Service Bulletin

**1. HDS 9/16 / 12/14 ST Gas
ionization electrode (6.526-216)****Service Bulletin
No. 2007-033 dated 05.12.2007
Classification level II**

Fig. 1: Old (top) and new (bottom) version of the ionization electrode (6.526-216)

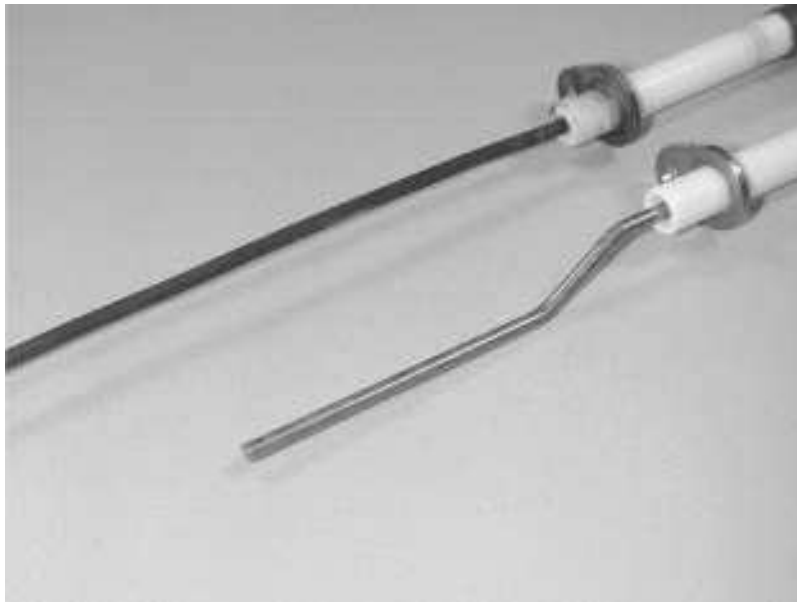
- Problem:** The short endurance of the ionization electrode frequently causes faults in the burner.
- Cause:** The long, straight shape together with the thermal load causes the ionization electrode to bend. A non-conductive oxide layer forms on the surface of the metal.
- Solution:** There is a new version of the ionization electrode, with different shape and material. The previous part number (6.526-216) is retained.
- Note 1:** Mount the ionization electrode at a distance of 8 to 10 mm to the fire tube and centrally to the hole in the ignition metal.

- Note 2:** When replacing the ionization electrode, please also fit the new ignition metal (5.044-832), see point 2 of this Service Bulletin.
- Note 3:** When replacing the ionization electrode and glow plug, please note:
- Replace O-ring 120 x 4 mm (6.362-954) on the burner flange and coat with silicone grease (e.g. 6.288-044).
 - Clean the contact area for the O-ring in the combustion chamber.
 - This is the only way to ensure that there is no leakage between burner flange and outer jacket.

Fig. 1: Seal, No. 4 (6.363-205),
between outer jacket boiler base

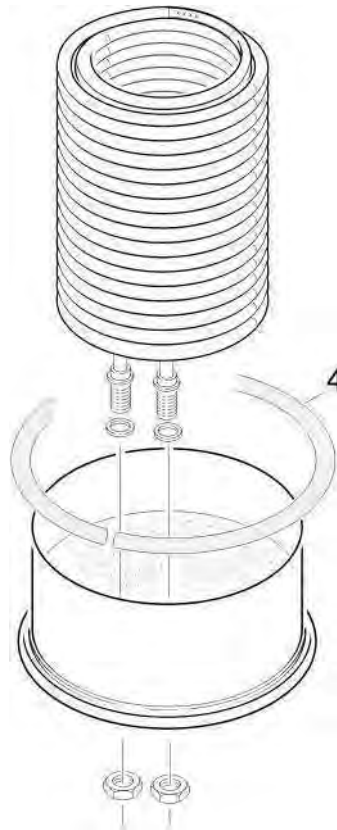
Note: Occasionally, the seal (6.363-205) between boiler base and outer jacket leaks.

The seal does not "lie" neatly in the seal edge or seal gap between outer jacket and base.

Rub silicone grease (e.g. 6.288-044) thoroughly into the seal before fitting in the unit.

Fig. 1: View into the outer jacket from below.
In the correct version, the frame is held by 8 welding points (encircled).

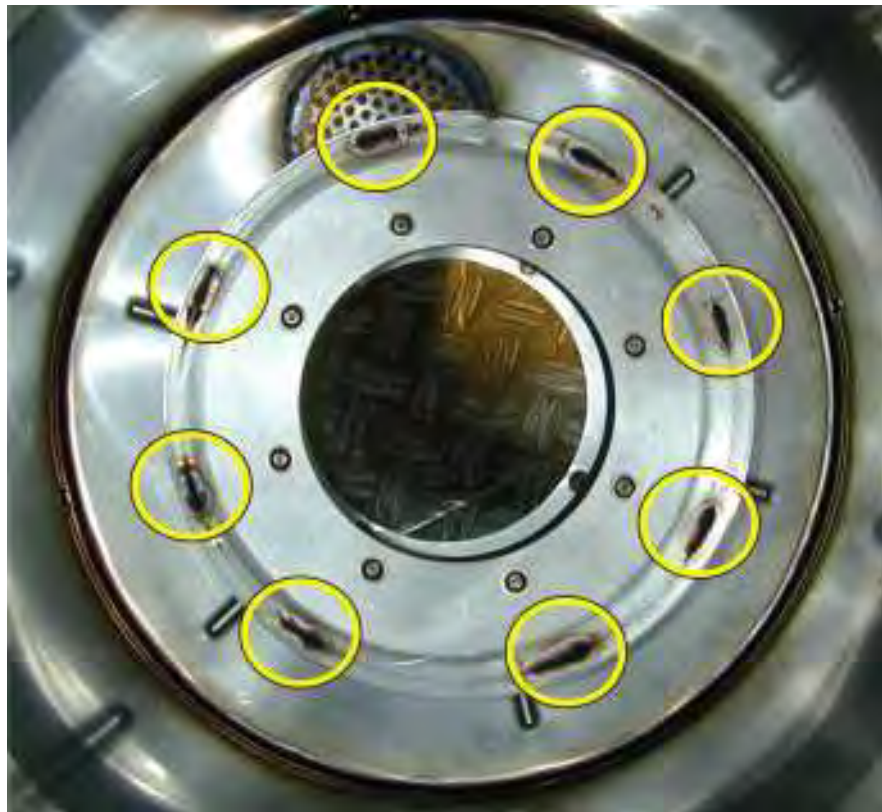
- Problem:** In units HDS 9/16 and 12/14 ST Gas (1.251-101/ -103/ -104/ -105/ -106), it is possible for the exhaust temperature of the burner to exceed the normal value. This may possibly trigger the exhaust temperature limiter.
- Cause:** The frame in the outer jacket (HDS 9/16 - 4.652-124 and HDS 12/14 - 4.652-142) does not have the specified number of 8 welding points. Thermal tension can cause the seam to open between the welding points.
- Solution:** If problems occur, then mount the correct outer jacket. The frame must be fastened with 8 welding points, see Fig. 1:

Fig. 1: The number of fastening shackles on the outer jacket will be increased in future from 3 to 6

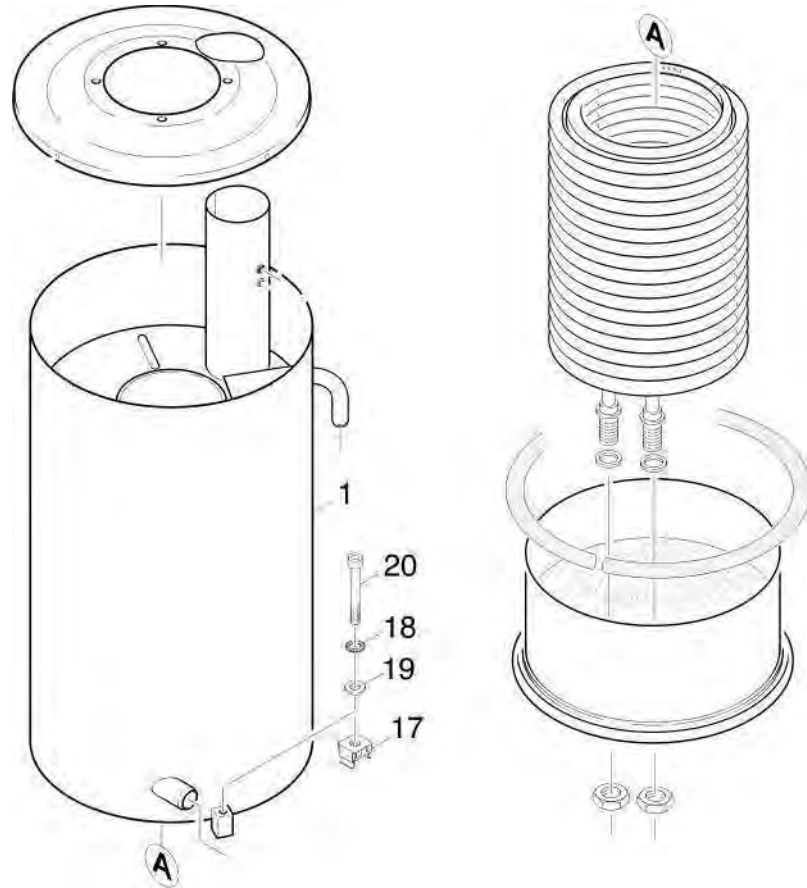
Note 1: The outer jacket (HDS 9/16 - 4.652-124 and HDS 12/14 - 4.652-142) cannot always be fitted closely onto the boiler base using the 3 fastening shackles, as the unit base can be distorted in the vicinity of the fastening screws.

Deformation of the unit base and possibly fastening points bent upwards.
Triggered by great forces of the boiler screws distributed on three small areas.

In future, the outer jacket will be changed over from 3 to 6 fastening shackles, while retaining the part number. The existing stocks of old outer jackets will be used up. Additional parts are needed to fit the new outer jacket, see also Fig. 1:

No. 17: 3 ea. nuts M8 (7.311-068), standard version
No. 18: 3 ea. tooth lock washer 8.4 (7.312-159)
No. 19: 3 ea. washer 8.4 (7.312-004) and
No. 20: 3 ea. screws, M8 x 50 (7.306-039)

Note 2: The three additional fastening shackles must be marked and drilled to the unit base with $D = 9.0$ mm.

Fig. 1: Seal, No. 3 (5.115-521)
between heating coil and boiler base

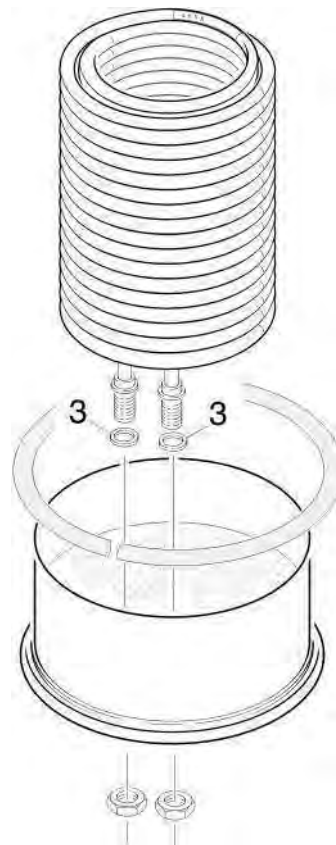
Note: The copper seals between the heating coil neck and boiler base are no longer impervious, leaking condensate and coolant.

Copper seals are used between the heating coil neck and the boiler base. Aggressive condensate in combination with the various metals corrodes them in time.

When repairing the heating coil and boiler base or when there are leaks here, the two copper seals should be replaced by 2 plastic seals (5.115-521).

The paper seal featured in Disis as spare part (5.365-068) is not suitable for use in gas units.
